APSU fail action

Leon Bruckman, Nvidia

Figure 178B-10—Training control state diagram

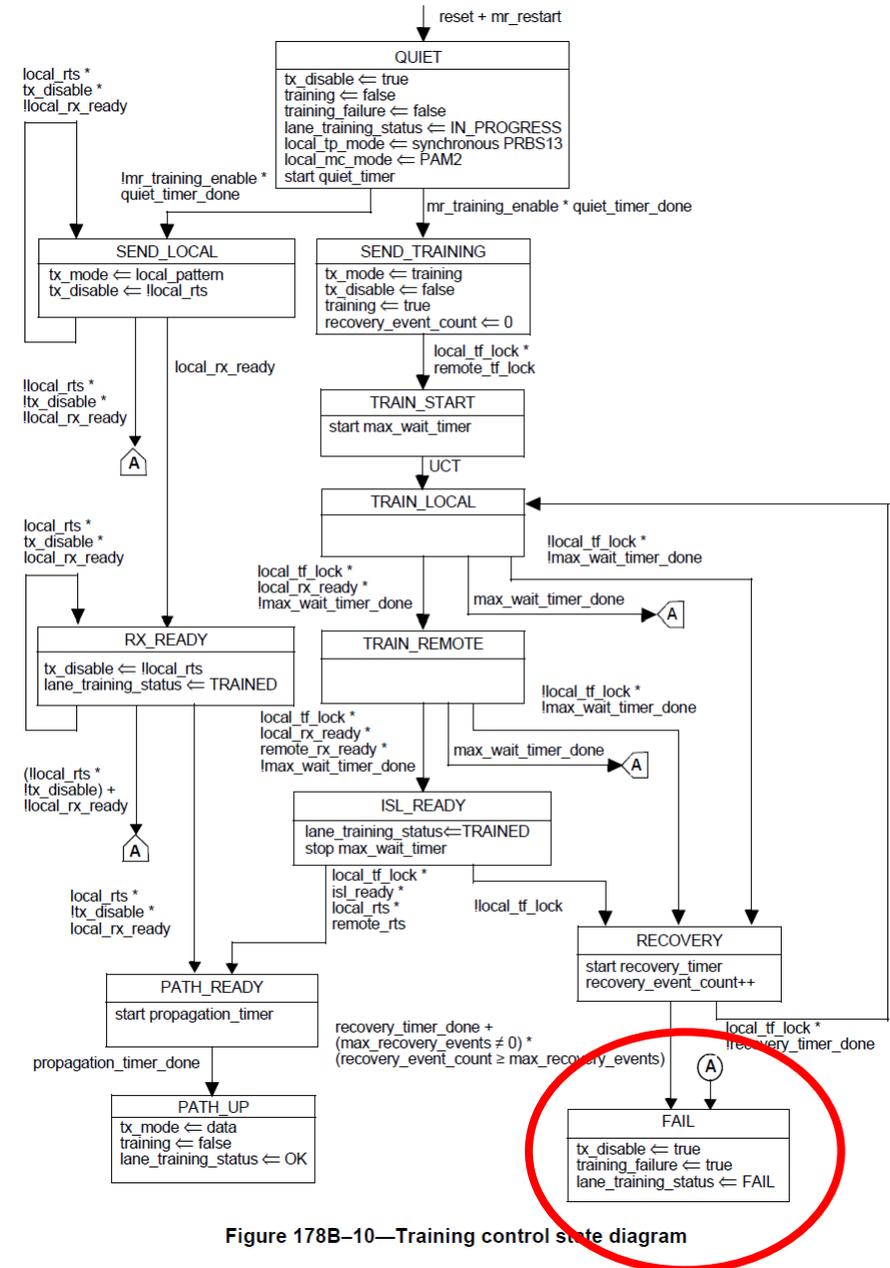
- In the “Training control state diagram” there is no indication how to exit the FAIL state.
 - The expectation is that the management takes care of the situation
- Lack of explicit specifications may lead to interoperability issues

- Add text to the note, or add a new note:
 - Recovery from FAIL state requires management to assert `mr_restart_training` or `reset`. The timing for this recovery is implementation dependent.

Expected behavior

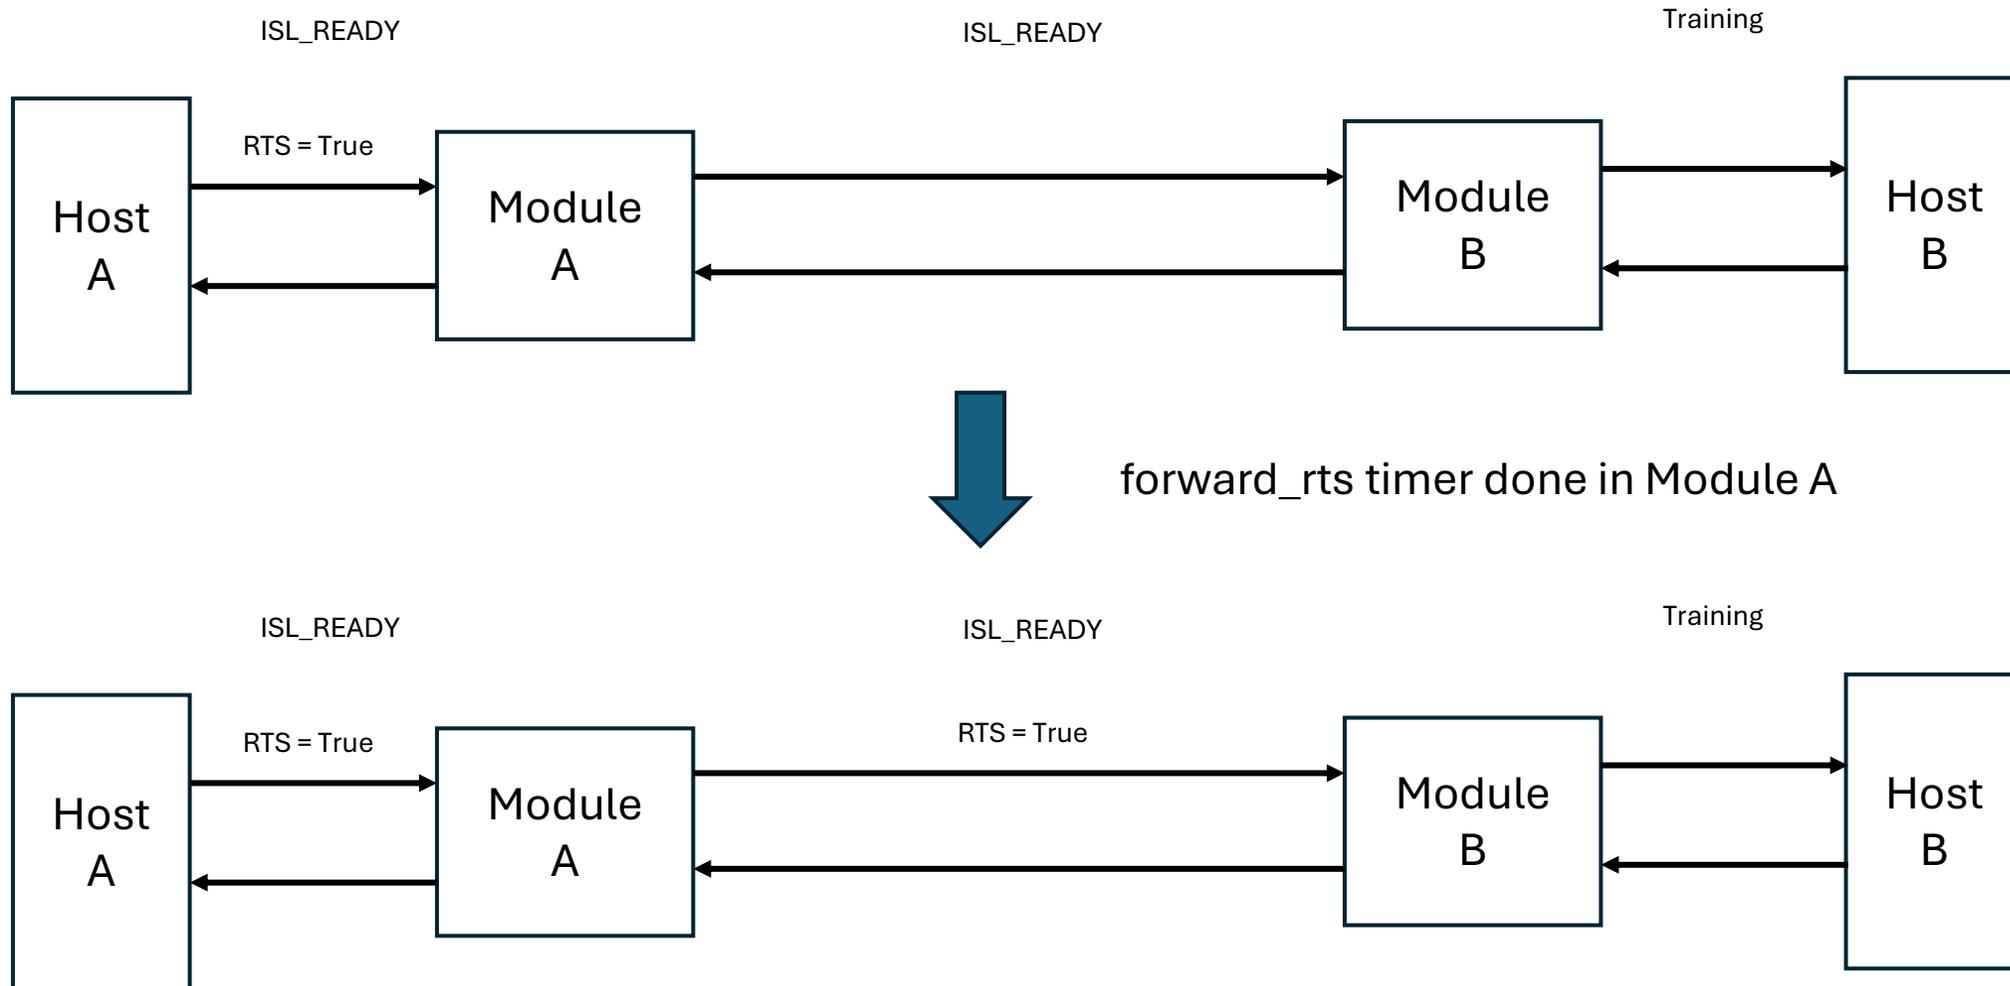
- If interface A of an ISL loses TF lock (`local_tf_lock = false`) and reaches the FAIL state in will set `tx_disable = true`
- Interface B (the peer interface in the ISL) will be either in the TRAIN_LOCAL, TRAIN_REMOTE or ISL_READY states waiting for responses from side A

- Interface B will lose TF lock (loss of signal) and also reach the FAIL state
- Management will need to decide if and when to restart APSU
- This is addressed by a note in D3.0:

- It is not clear if reaching the FAIL state is an unrecoverable fault
- The live-lock situation may occur if an ISL in the path is already in the PATH_READY state

- This live-lock situation is resolved by the APSU restart proposal
 - See separate contribution

Live-lock situation - 3

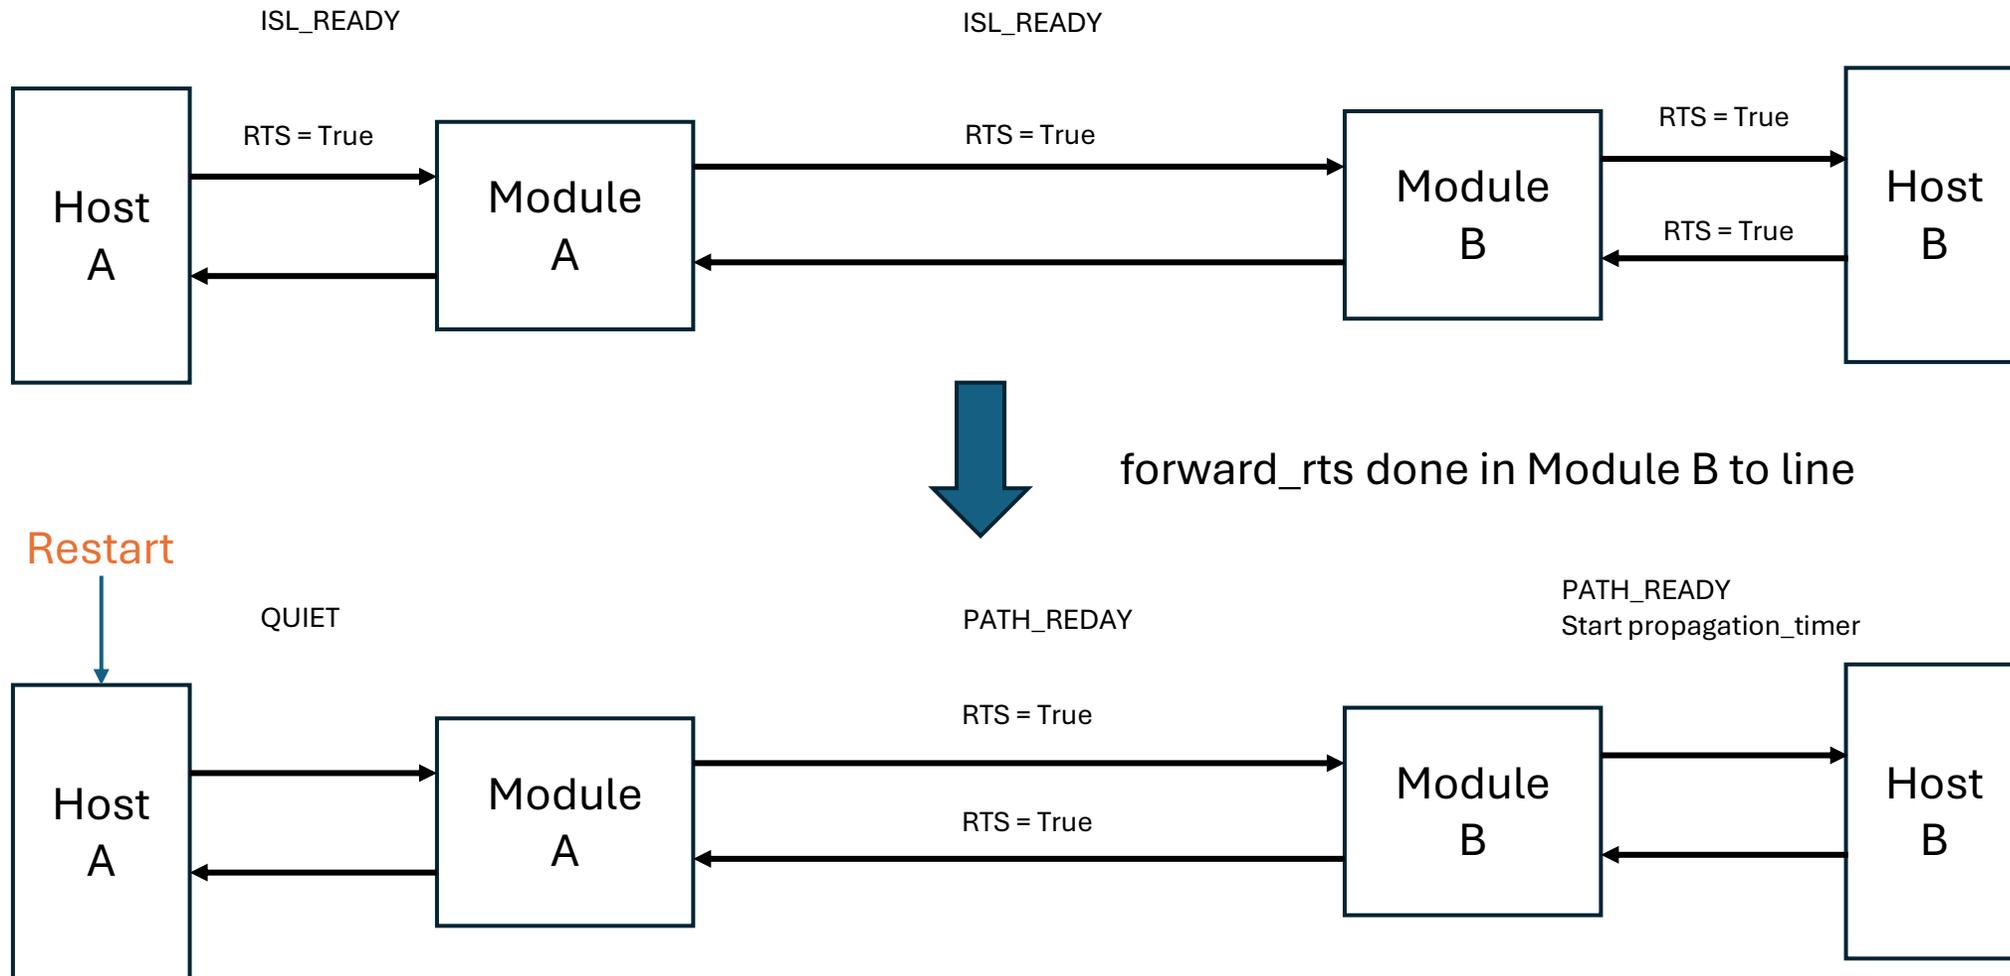
- Host B will move to `PATH_UP` after `propagation_timer` expires
- Host A will wait for `ILT` frames to move from `QUIET` state to `SEND_TRAINING` state
